DEVELOPMENT DETERMINATION PANEL MEETING

WEDNESDAY 24 NOVEMBER 2021

**Agenda for a Meeting of the Development Determination Panel
to be held on Wednesday 24 November 2021
via teleconference
Commencing at 10.00am**

ITEM 3.1	DA2021/0905 - 53 WHEELER PARADE, DEE WHY - DEMOLITION WORKS AND CONSTRUCTION OF A DWELLING HOUSE INCLUDING A SWIMMING POOL
REPORTING MANAGER	Tony Collier
TRIM FILE REF	2021/795454
ATTACHMENTS	1 Assessment Report 2 Site Plan and Elevations

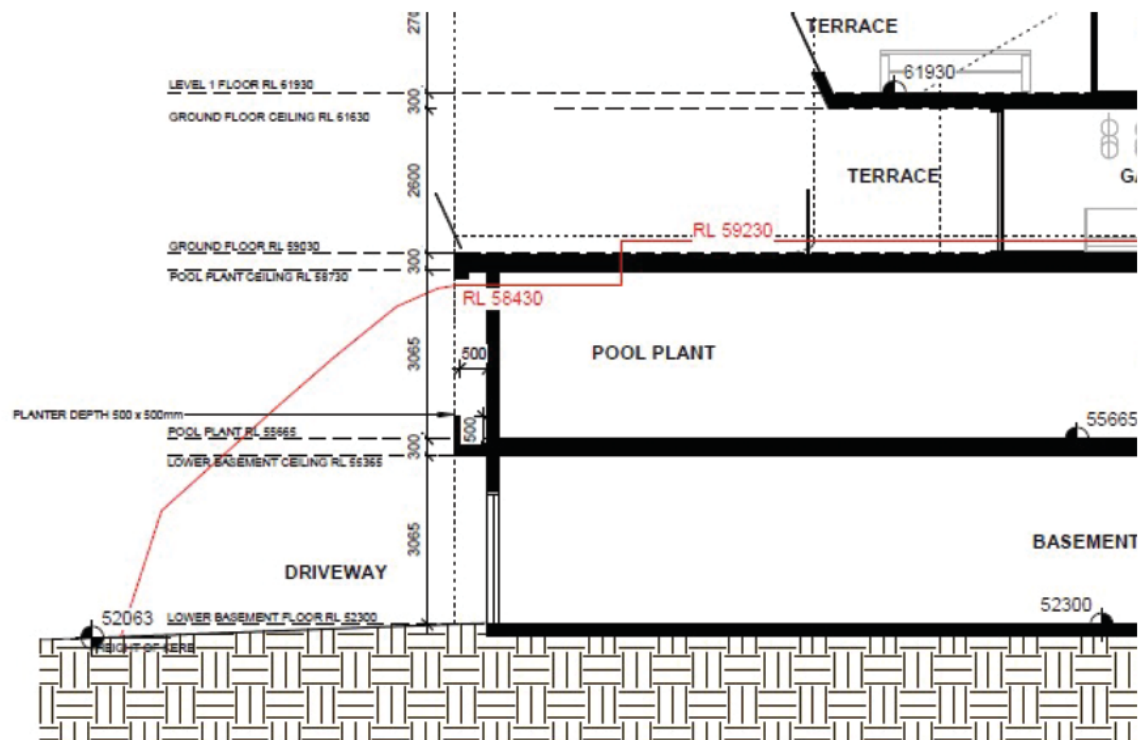
The natural topography of the land makes it difficult for an open streetscape presentation to be provided given that a 6m high rockface exists immediately inward of the sites front boundary, for the width of the block. This development however reduces an already compromised streetscape presentation and sense of openness.

The development seeks to excavate the majority of the site frontage to accommodate the basement and swimming pool which in effect creates a 6.73m high solid wall positioned with a setback varying from zero to 0.5m to the front boundary, topped with a boundary fence with a minimum height of 1m. Not only is this structure almost 100% non-compliant with the front setback control, the height of the wall (with fence) right at the boundary results in a maximum wall height that exceeds the maximum prescribed by Clause B1 of the DCP.

The only attempt to screen the proportions of the aforementioned front wall is an elevated 0.5m wide by 0.5m deep planter box. That planter box is inaccessible and sits beneath the

overhanging slab of the ground floor terrace which would severely impede natural light to allow the plants to grow.

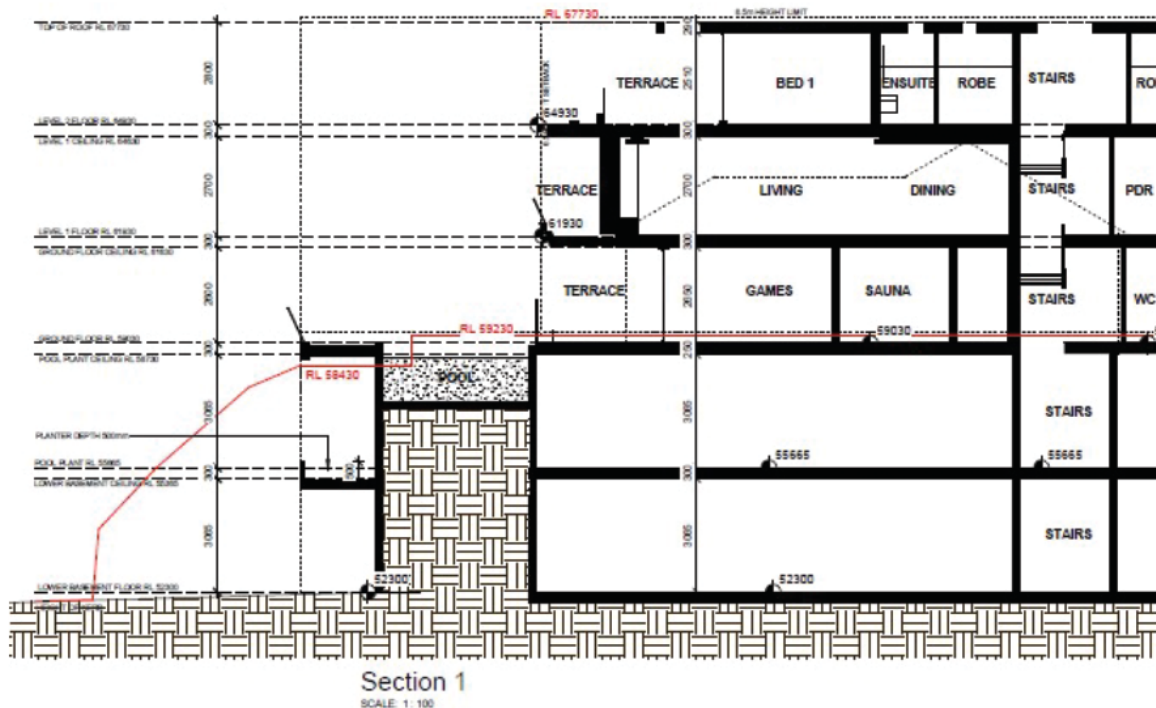
The application and its accompanying documents are silent on why such a large basement is required to be excavated for a single dwelling house and provides minimal detail as to what this space is used for site with the exception of garaging vehicles, air conditioning and pool plant equipment. Both levels of basement have bathrooms and stair and lift access.

The level of excavation contravenes Requirements 2 of clause C7 which read as follows (emphasis added):

Figure 2B – 8.5m Height Plane Measured from Previous Existing Ground Level (Dwelling After Alterations/Additions)

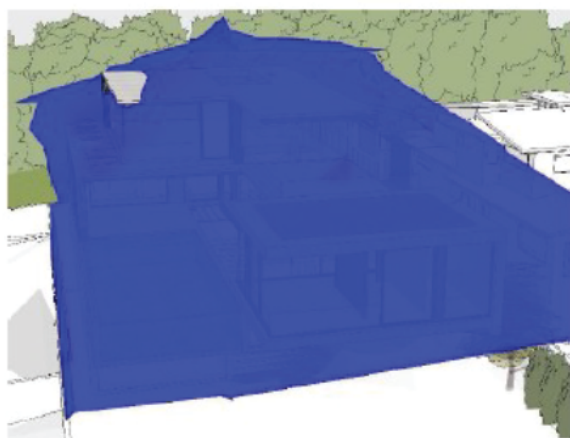
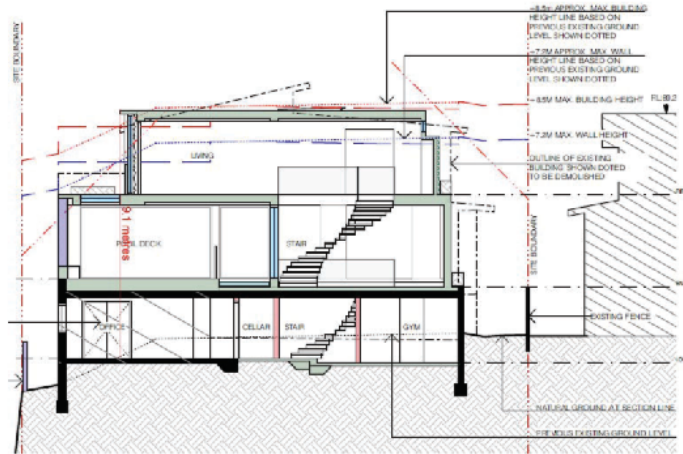
Development standard:	Height of buildings
Requirement:	8.5m
Proposed:	9.7m
Percentage variation to requirement:	14%

The non-compliance is limited to the south-western corner of the building and is partially as a result of the topography of the land, with the land falling away as a result of previous excavation at the south-western corner.

The above figure on the left demonstrates the 8.5m height plane of the proposed development. The ridge line of the south-western corner of the first floor was approved at RL69.21 under the LEC approval. The proposed development is at RL 69.41 (i.e. +0.2m) at the south-western corner and therefore, the proposal consists of a similar departure from the development standard as approved under the previous application by the LEC.

Figure 1 - Extent of envelope non-compliance shown in red. Northern elevation left, southern elevation right.

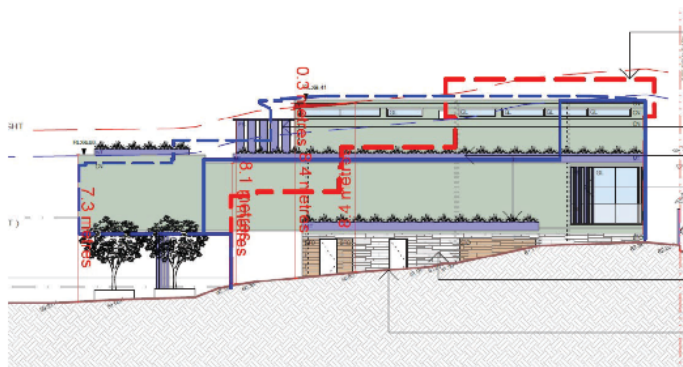
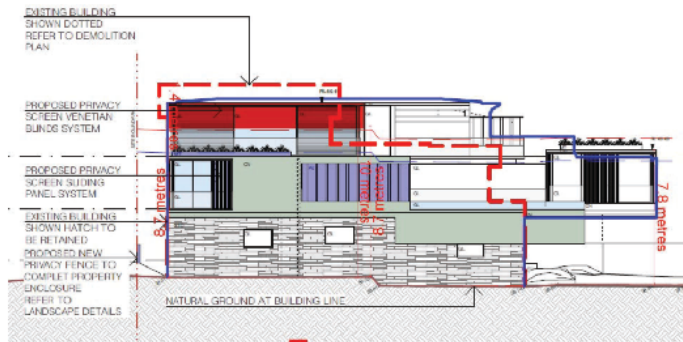
The proposed development has a non-compliance with the building envelope on the northern side of up to 300mm. The proposal also has a non-compliance with the building envelope on the southern side of up to 1.4m. The two figures below show the extent of non-compliance. It is noted that a portion of the southern building envelope non-compliance is an existing situation for the dwelling on the site, with alterations proposed to this section of wall.

In considering this particular proposal, it is also relevant to consider the extent of non-compliance to the building envelope approved by the Land and Environment Court (LEC). An extract showing the extent of southern envelope non-compliance of the LEC Approval is shown below. As seen in the below figure, the proposed development reduces the extent of non-compliance for the southern building envelope when compared to the LEC approval.

Based on this comparison, Council does not have a concern with the extent of envelope encroachment for the proposed southern envelope and therefore the envelope encroachment is not a reason for refusal.

Figure 4 – Standing, looking south-east out of the southern window of bedroom 2. Left pole is proposed development, right pole is LEC approval.

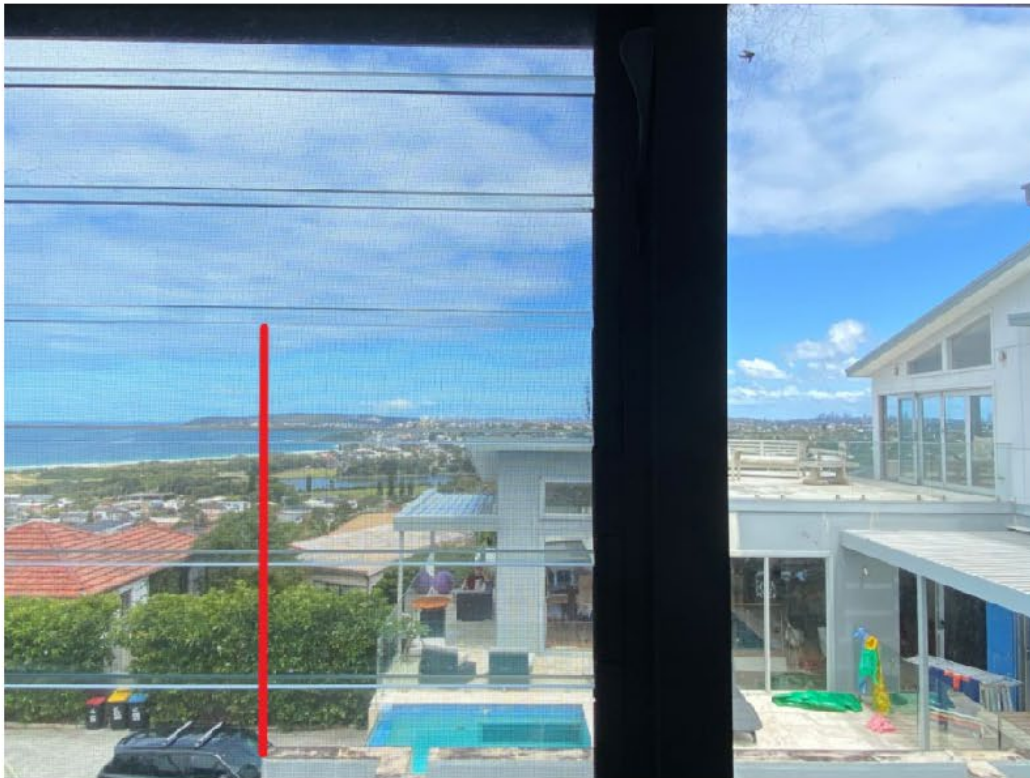
The LEC approval retained a small corridor of beach (as shown in **Figures 4 and 5 of Attachment 1**) looking out the southern and eastern window. However, the proposed master bedroom design results in further impact and complete removal of the view of Curl Curl Beach. It must also be considered the extent of impact the proposed top floor addition will cause to Bedroom 2, with the proposed first floor addition generally aligning with the pool area (**Figure 6 of Attachment 1**). No height pole was erected, however Figure 6 shows the extent of views to be impacted looking due south which contain district views of Manly and the southern end of Curl Curl Beach. When viewing Figure 4, the views towards North Head will be impacted by the

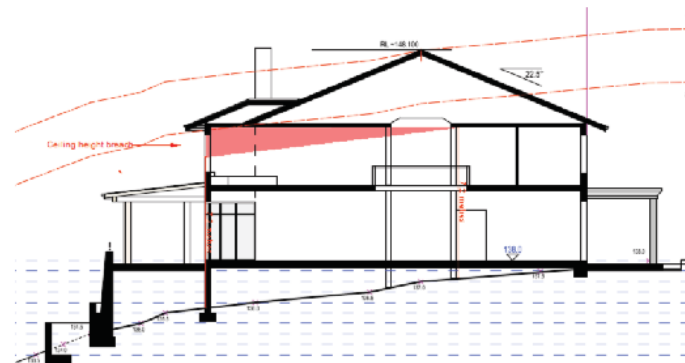
The wall height varies between 6.9m to 8.5m and is calculated as breaching the control by 1.3m which equates to a variation of 18%, see image below.
